# Planning Approval Consistency Assessment Form

SM-17-00000111

<b>Assessment name:</b>	SWM Stage 1 – Tunnel realignments
<b>Prepared by:</b>	Sydney Metro
<b>Prepared for:</b>	Sydney Metro
<b>Assessment number:</b>	SMW03
<b>Status:</b>	Final
<b>Version:</b>	1.0
<b>Planning approval:</b>	SSI-10038
<b>Date required:</b>	September 2021
<b>iCentral number:</b>	SM-21-00278719
© Sydney Metro 2020

Figure 2: Indicative alignment plan and long section between Burwood North Station and Five Dock Station (Figure 9-2(f) in the Stage 1 EIS)

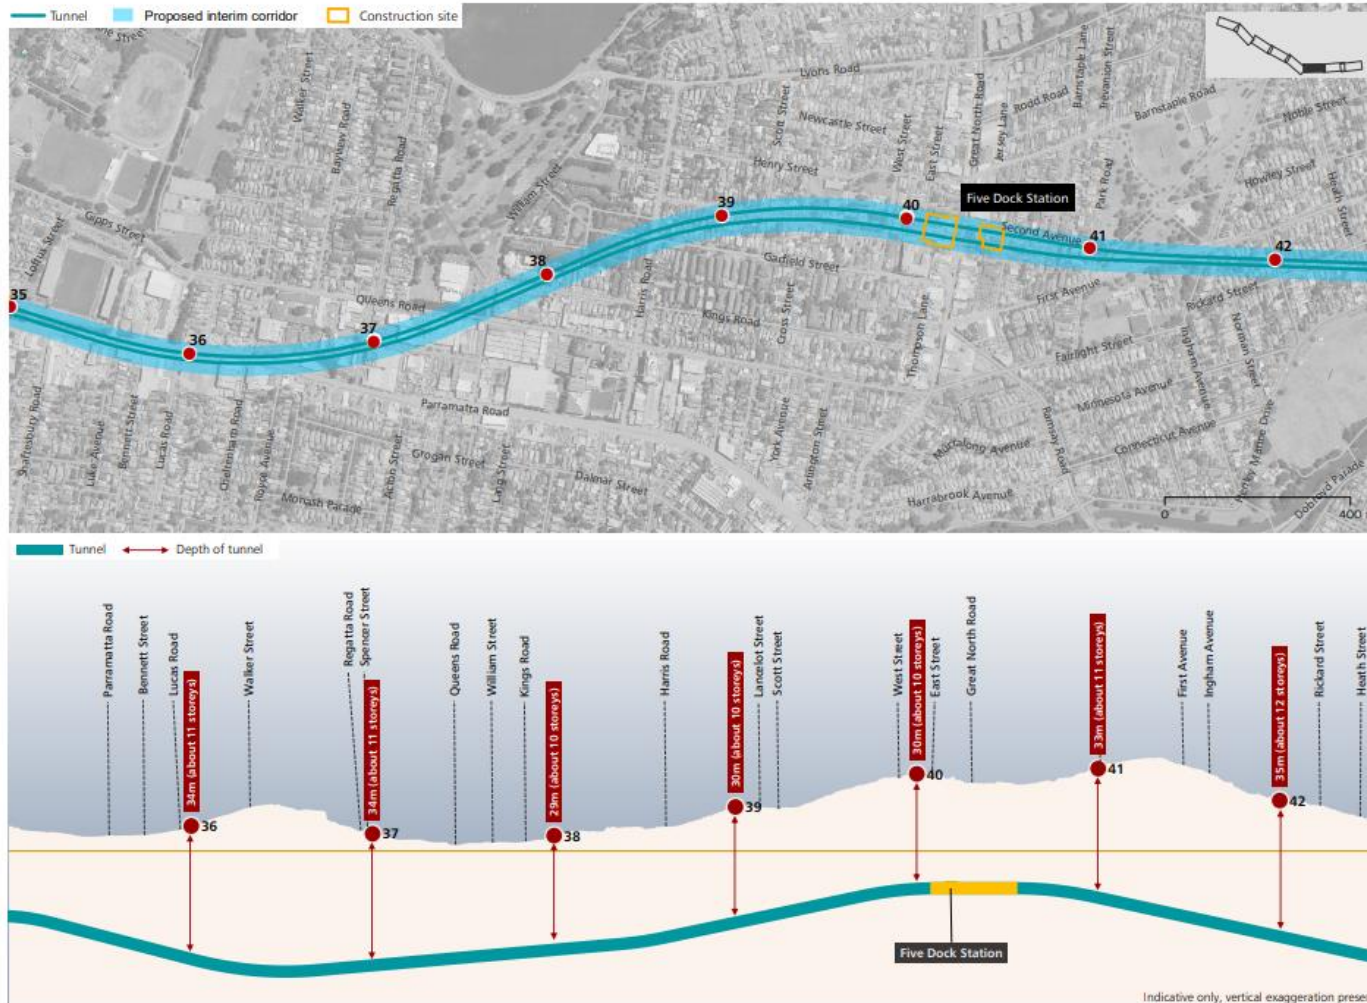
The purpose of this Consistency Assessment is to assess a minor tunnel realignment between Burwood North Station and Five Dock Station, and between Five Dock Station and The Bays Station. The relevant sections of the approved tunnel alignment, and the proposed revised tunnel alignment is shown in Figure 4 and 5. The proposed change in tunnel alignment is located entirely underground and the depths of the realigned tunnels would be similar to the relevant sections of the approved tunnel alignment (see Figures 2 and 3).

Figure 5: Approved tunnel alignment and proposed tunnel re-alignment between Five Dock Station and The Bays Station

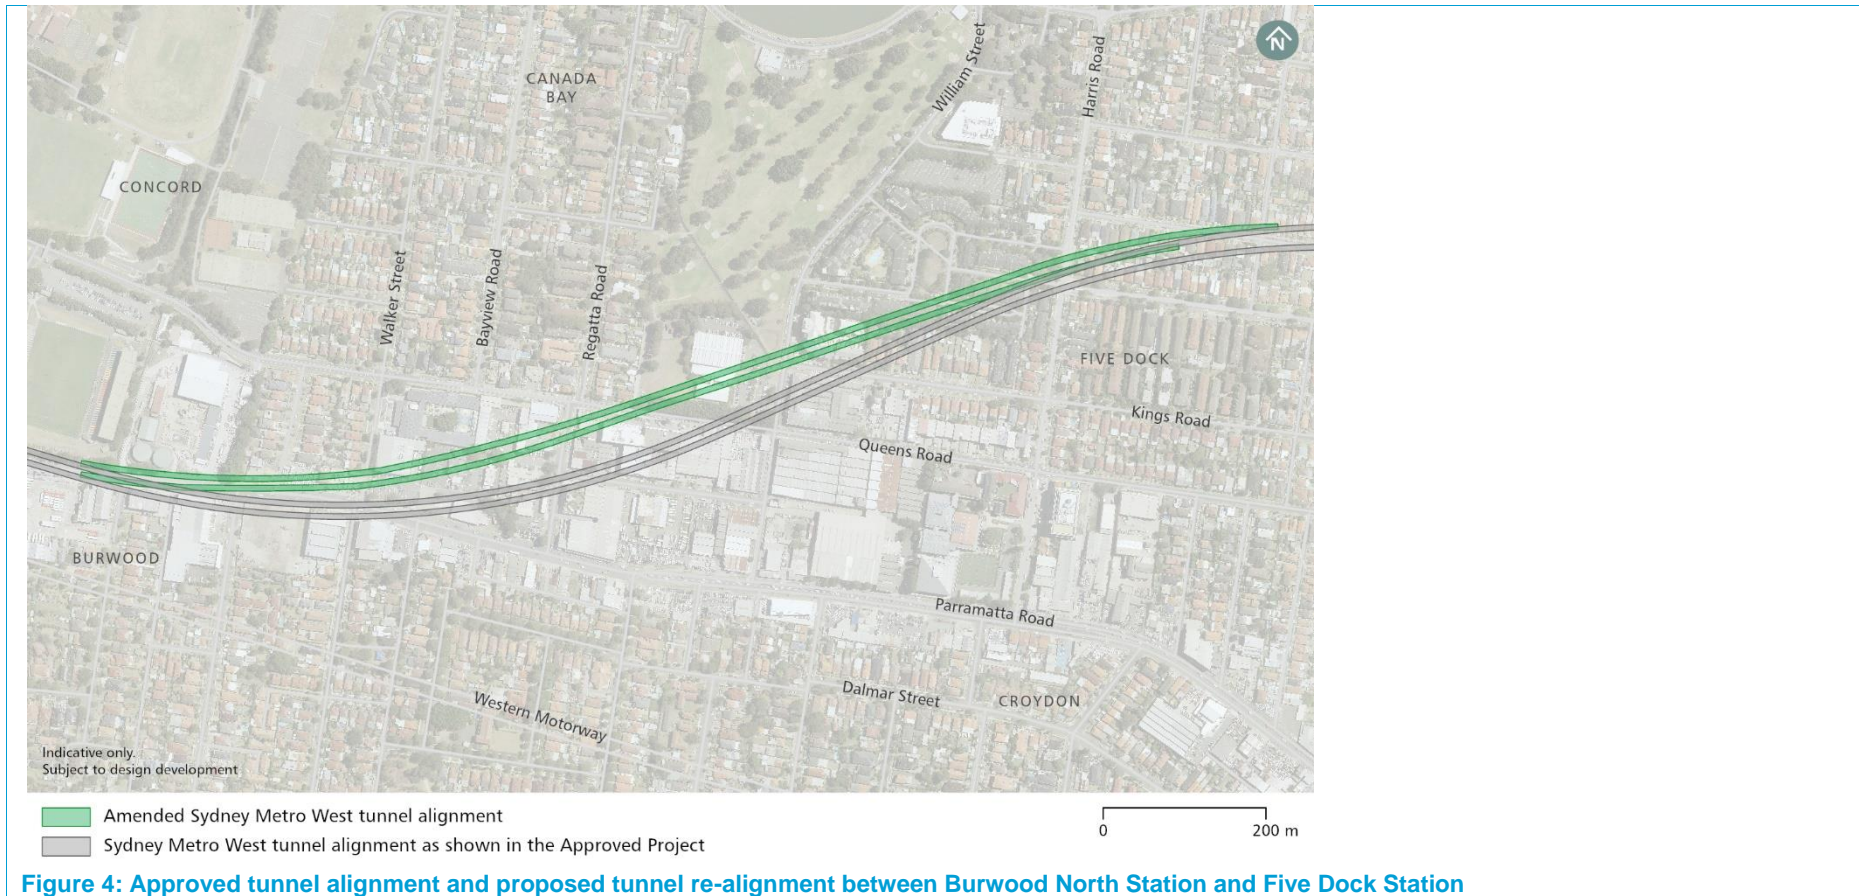
The minor tunnel realignment has been identified through detailed design opportunities to reduce the length and curvature of the tunnel alignment. This results in a more efficient construction process and cost savings.
